**Rancho Las Virgenes
Regional Facilities Expansion IV**

Solids Handling and Composting Facilities

LAS VIRGENES MWD / TRIUNFO CSD
RANCHO LAS VIRGENES - REGIONAL FACILITIES EXPANSION IV
SOLIDS HANDLING AND COMPOSTING FACILITIES

ANAEROBIC DIGESTERS AND
 DIGESTER PUMP STATION

IS-II
OF 508 SHEETS

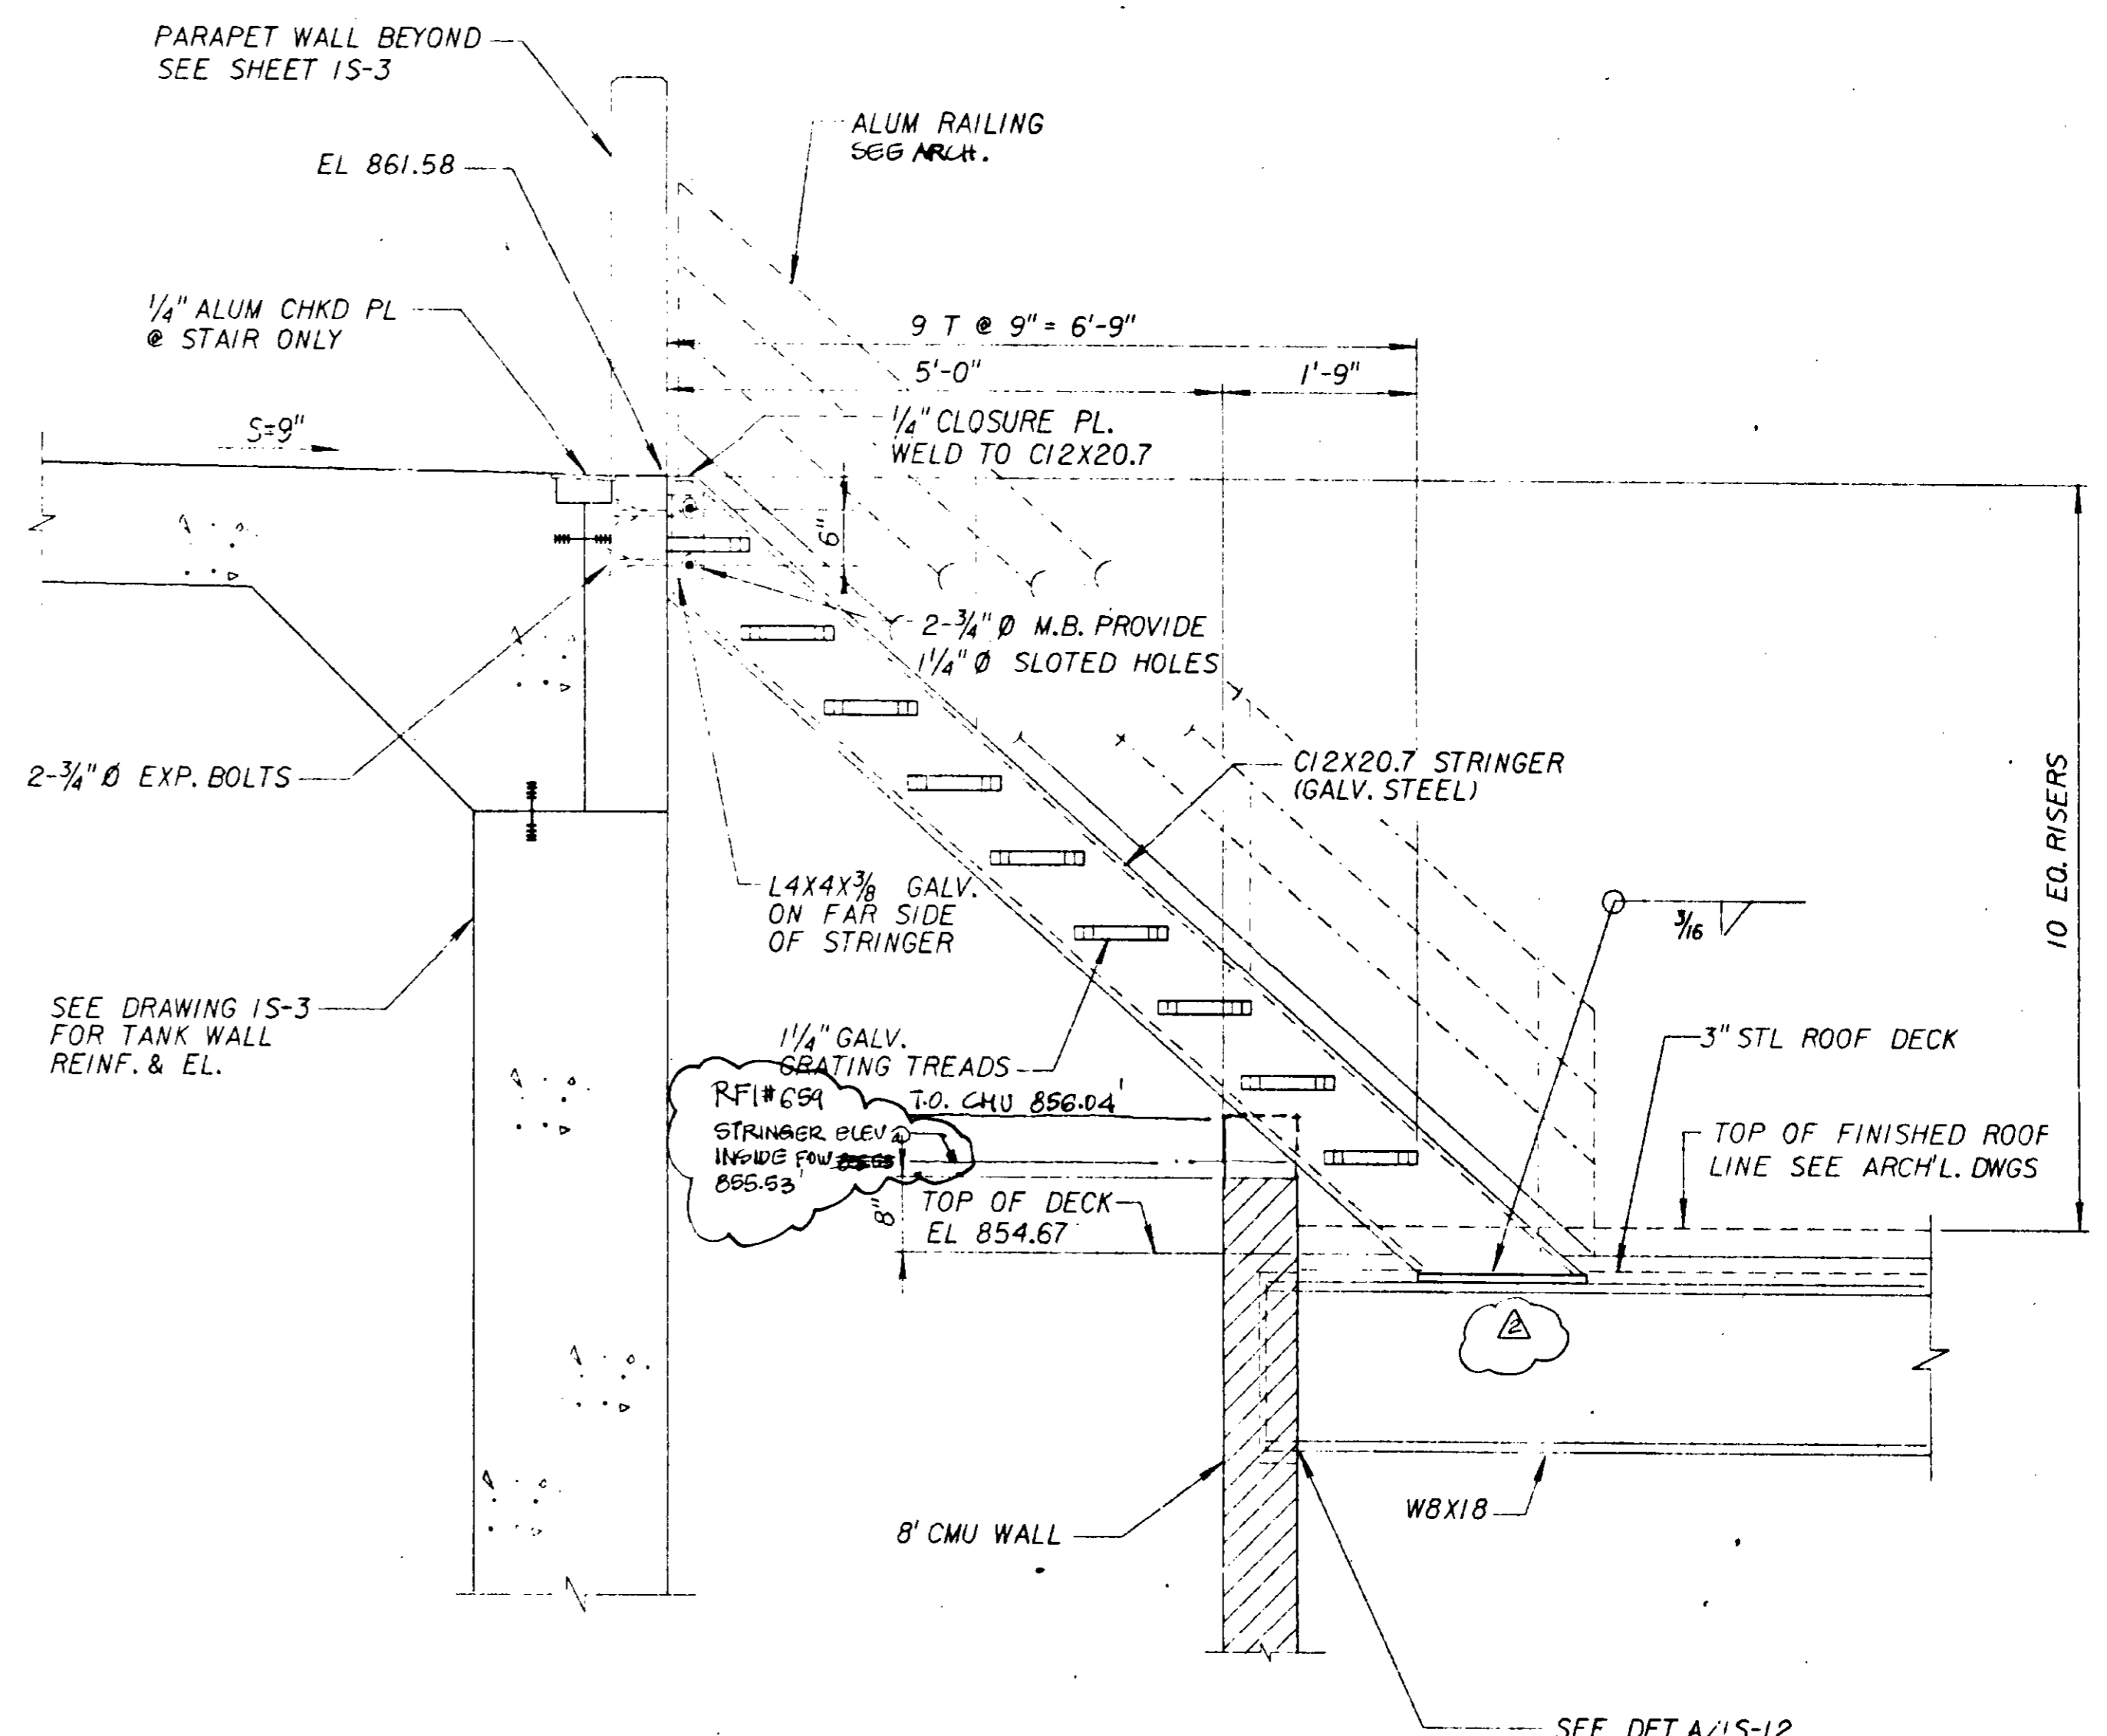
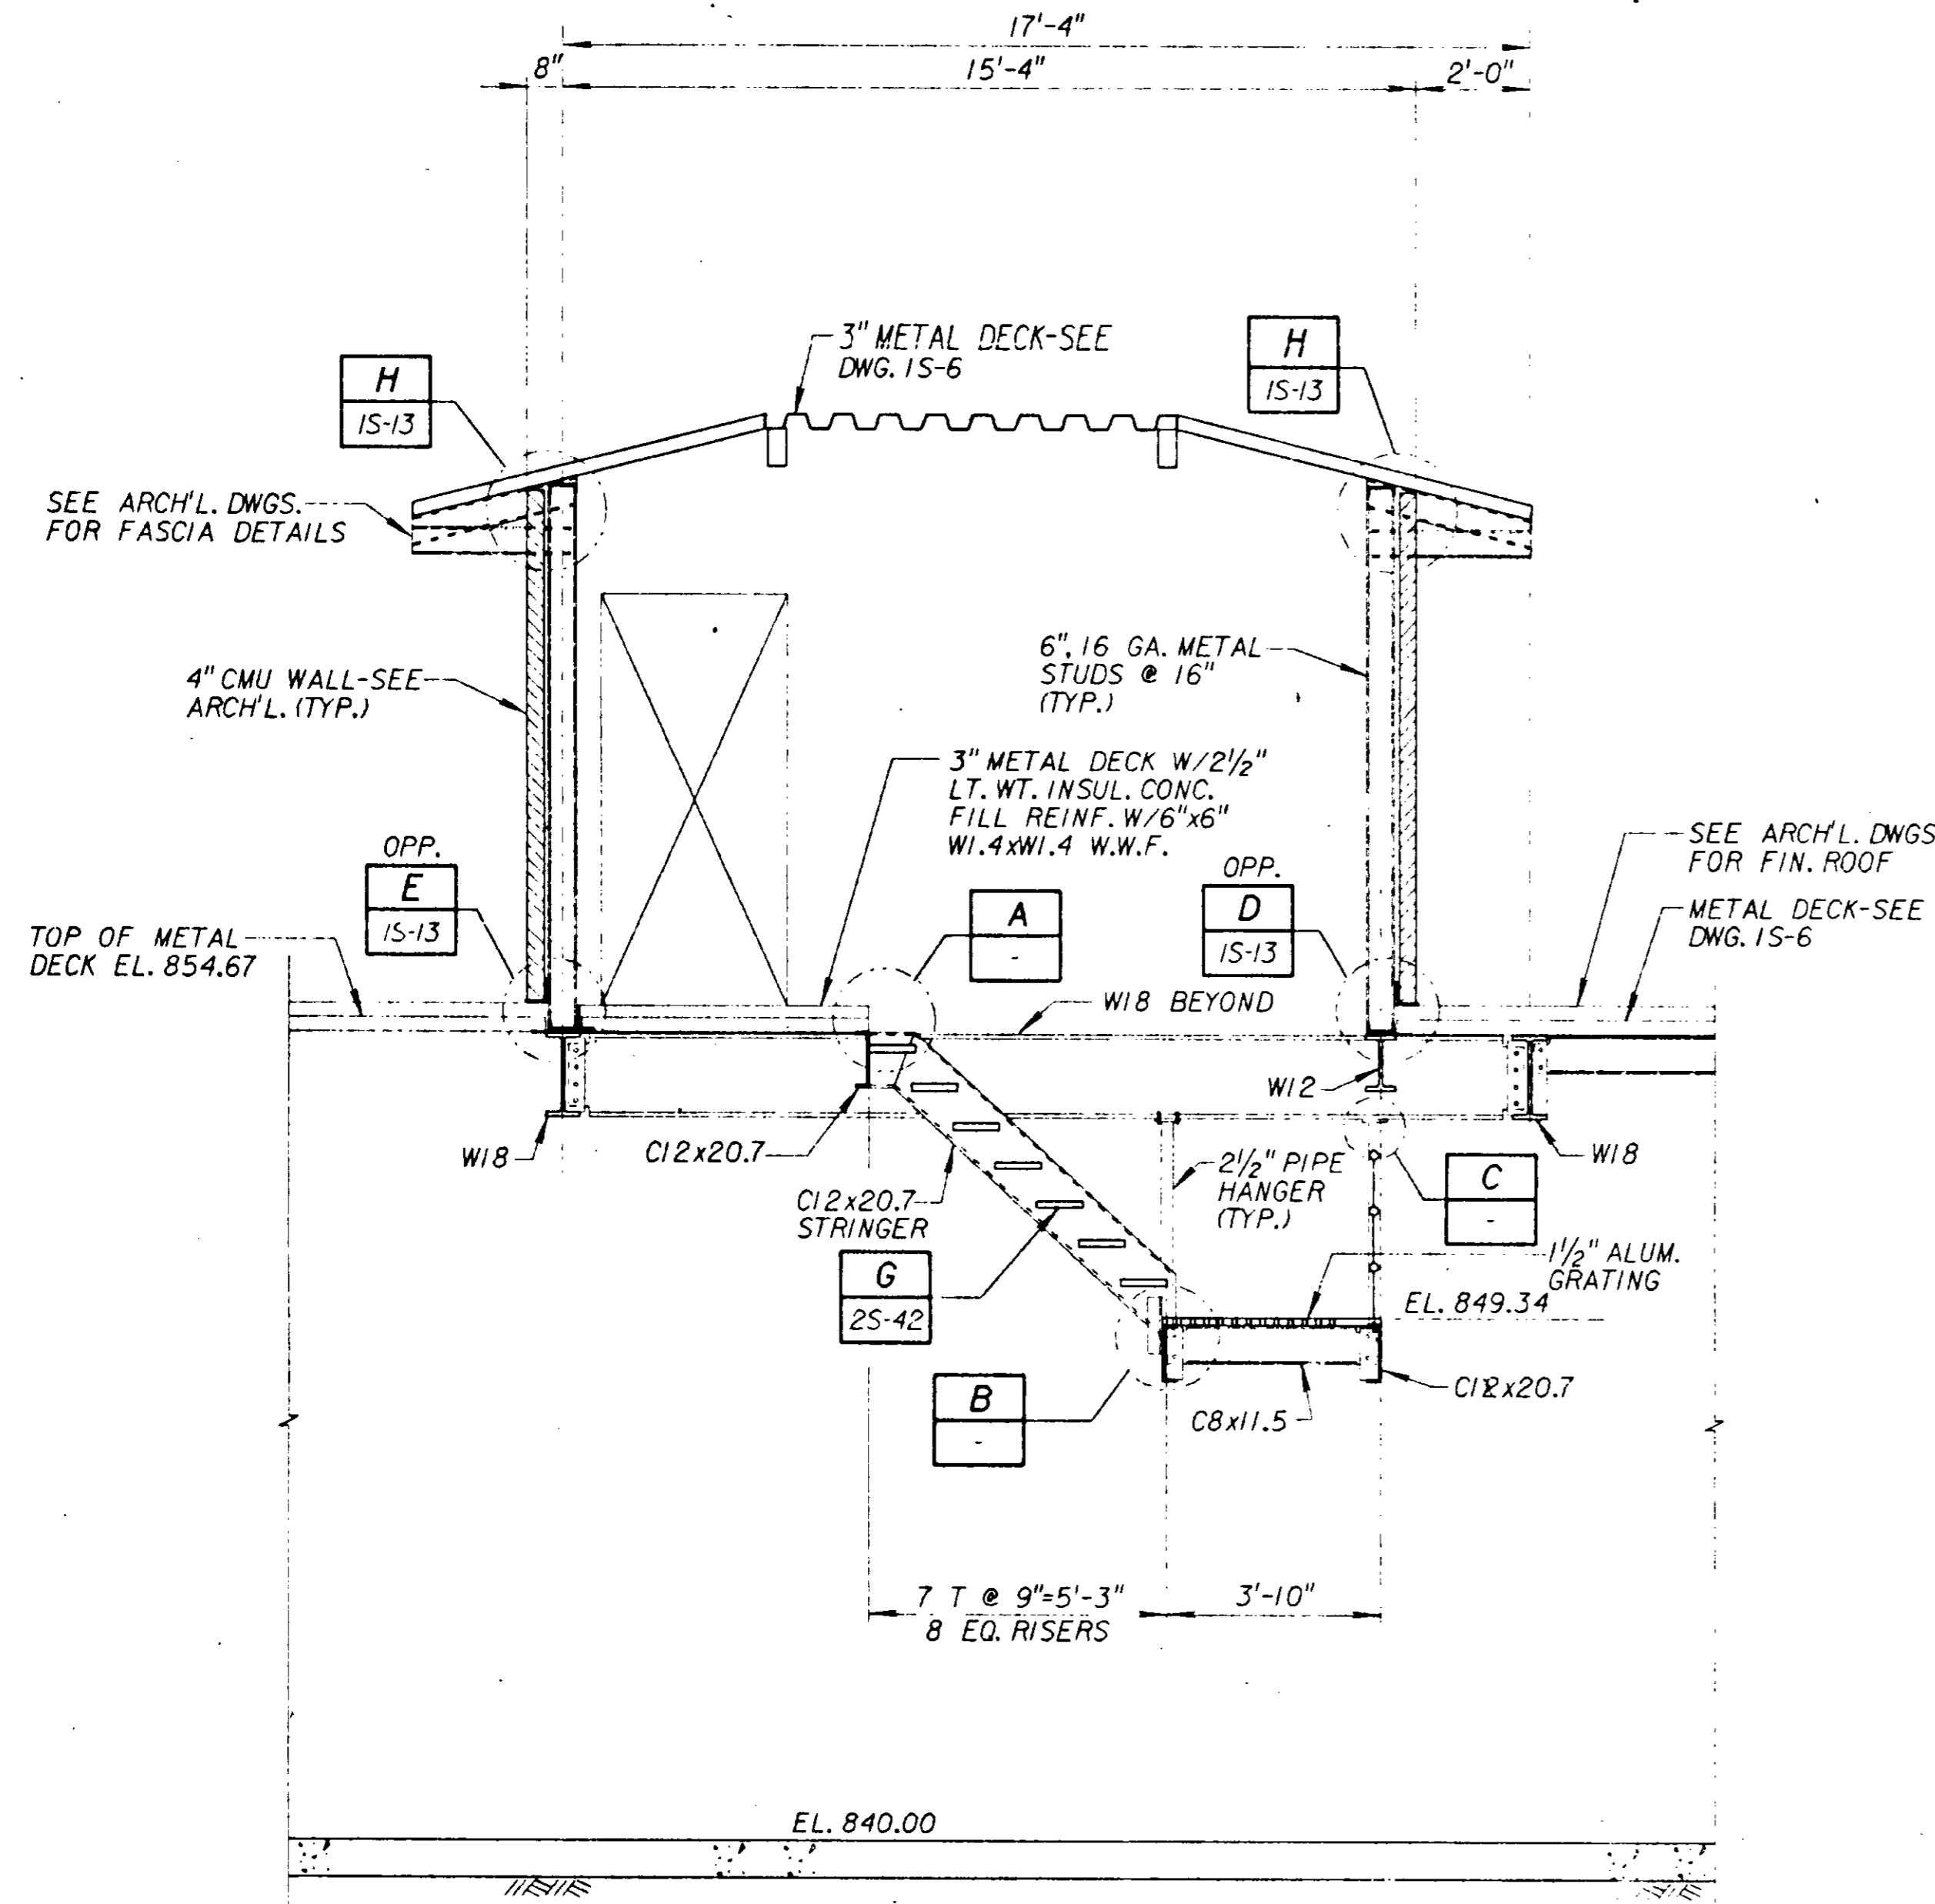
RFI # 706.
DUE TO PIPE COLUMN BEING 3/4"
TOO LONG - PIPE COL. TO BE
CUT, PLATE MOVED & REWELDED
PER ATTACHED DETAIL.

IS-12a

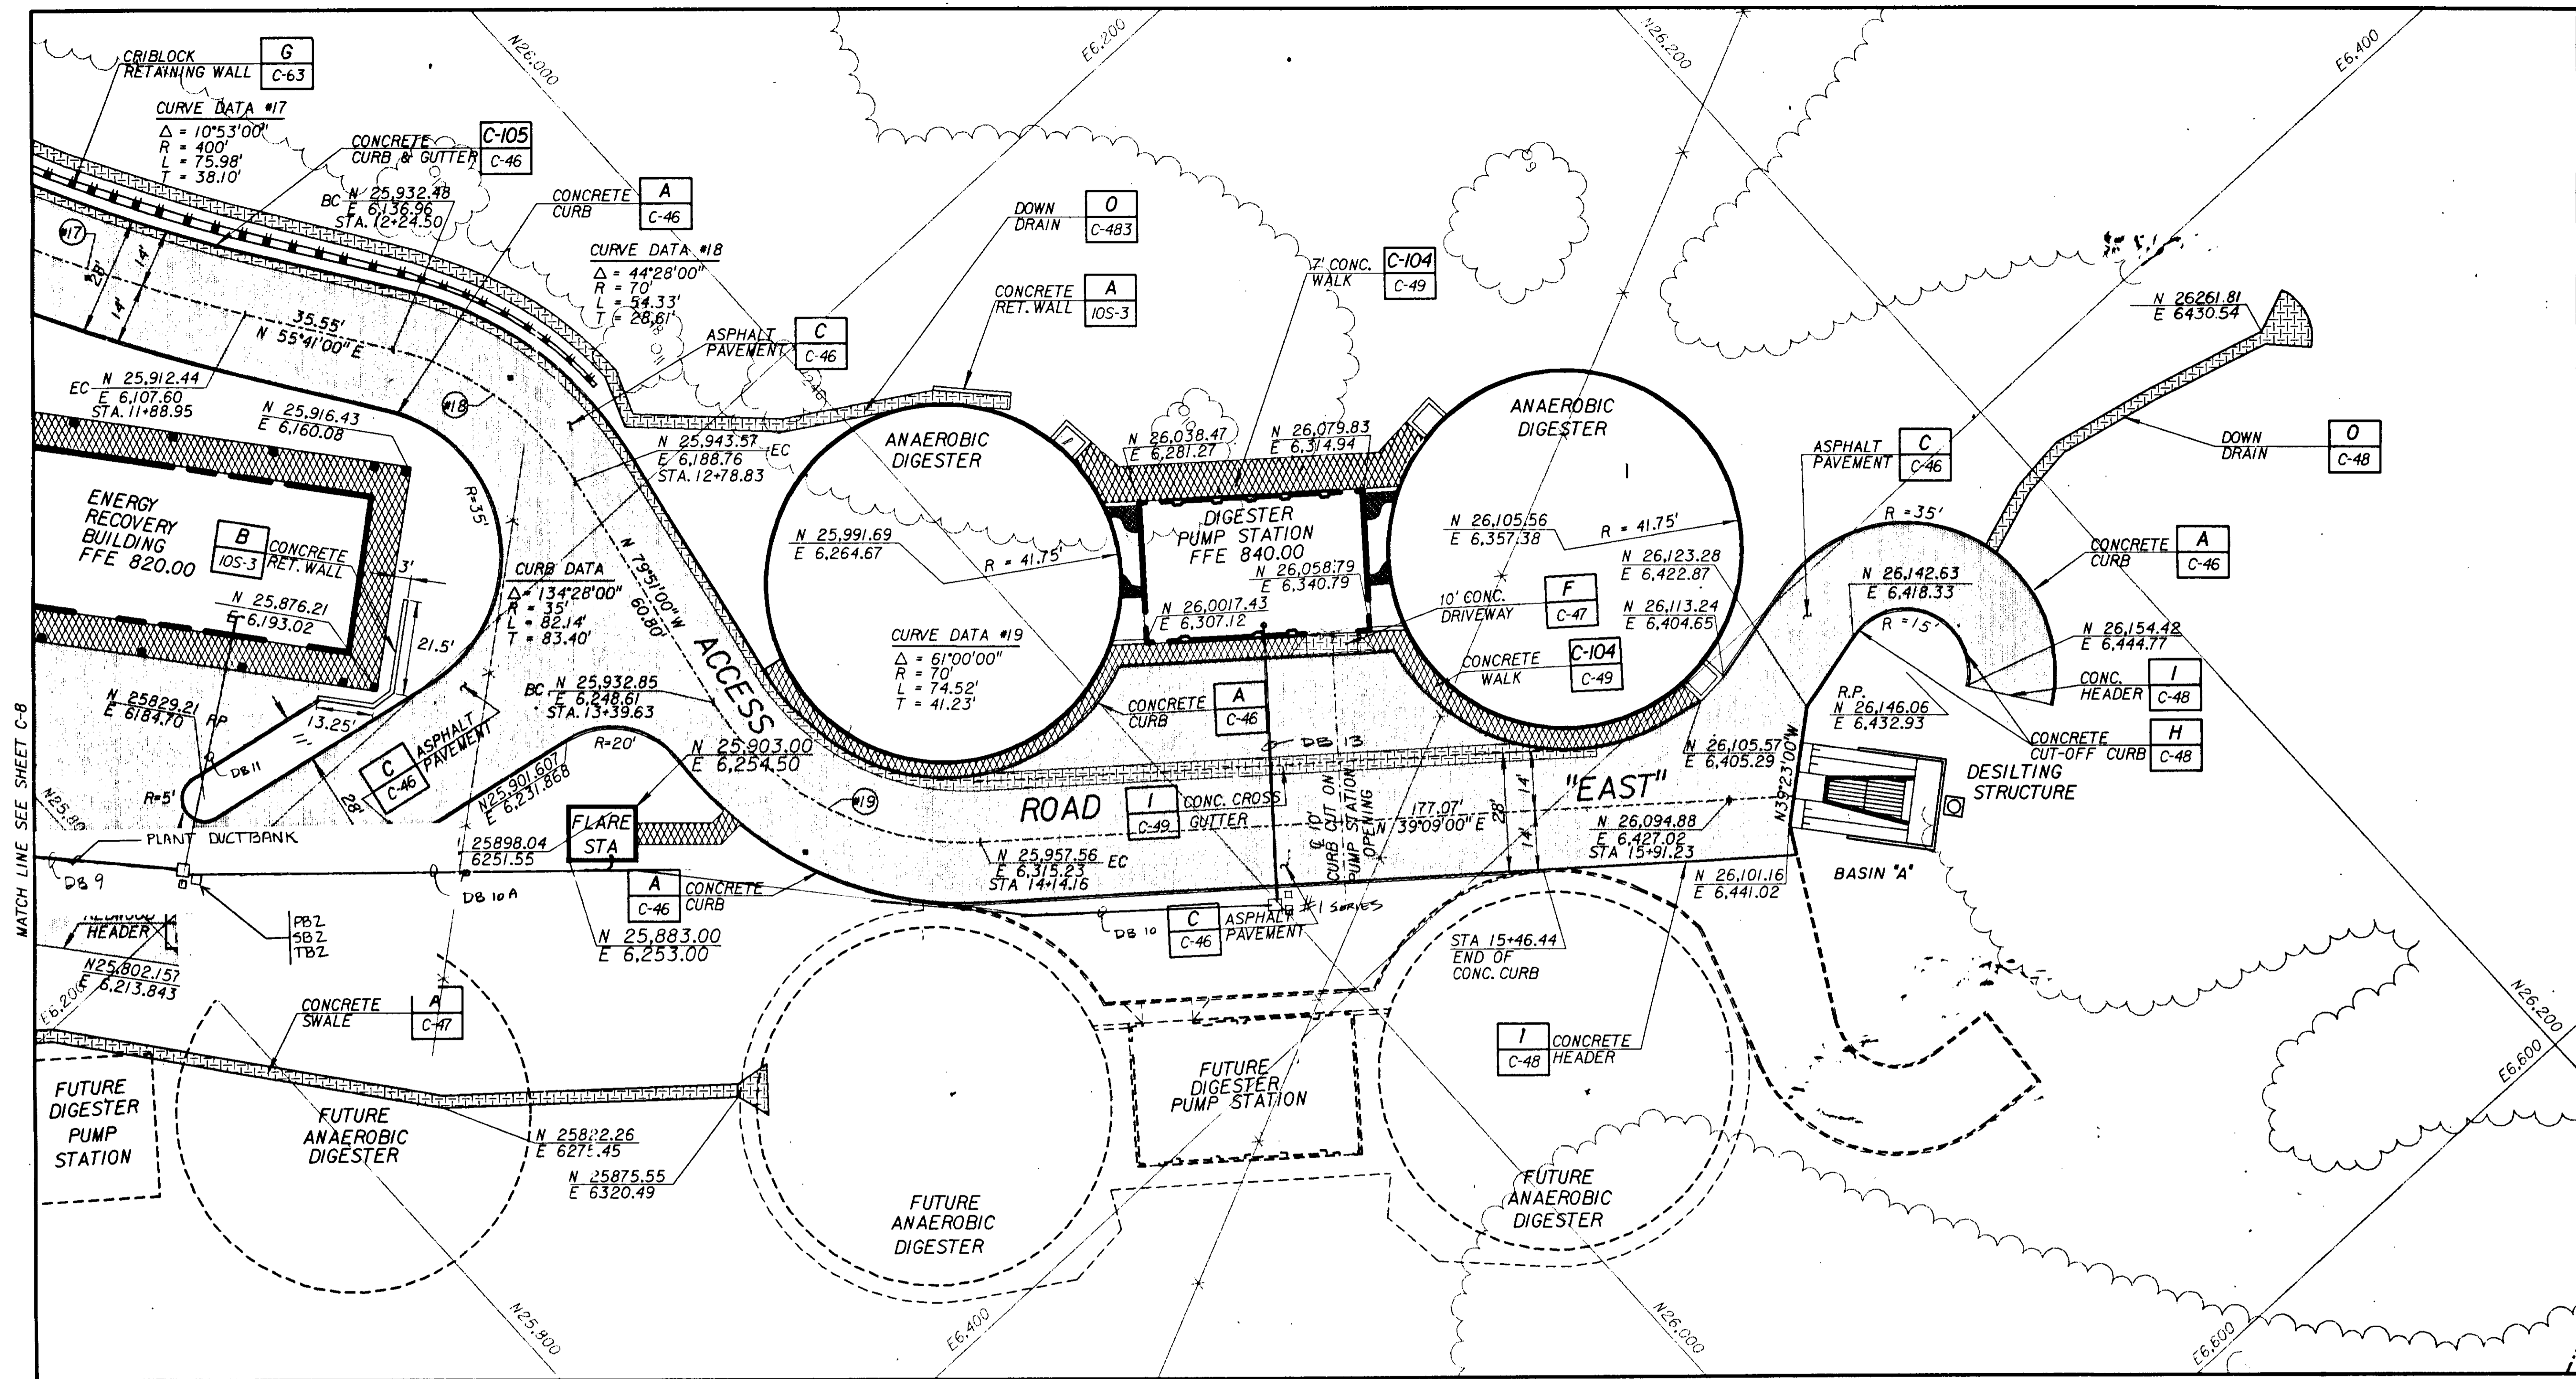
RFI # 706 ; ITEM # 1
REF. DETAIL L/S-12
FOR LOCATIONS NOTED AS "BB" ON PLAN ATTACHED.
NTS

RFI # 706 ; ITEM # 1
REF. DETAIL B/S-12
FOR LOCATION NOTED AS "AA" ON PLAN ATTACHED.
NTS
